## C2PC Request Letter

Class II permissive change for **FCC ID: 2BH7FBE220**

(Original Grant Date: 03/19/2025)

|         | FEM (Previous)                                                                      | FEM (New)                                                                            |

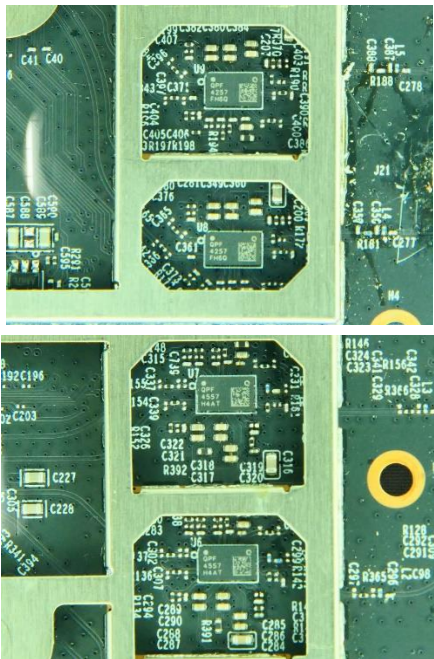
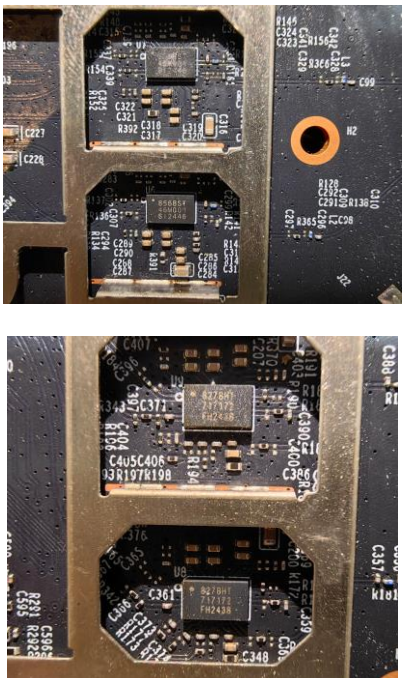
**the Wi-Fi 2.4GHz and 5GHz FEM (Front-end Modules) ICs have been changed. And the new FEM IC is Pin-to-Pin compatible with the previous one.**

|         | FEM (Previous)                                                                      | FEM (New)                                                                            |
|---------|-------------------------------------------------------------------------------------|--------------------------------------------------------------------------------------|
| Model   | QPF4557/QPF4257                                                                     | KCT8568ST/KCT8278HT                                                                  |
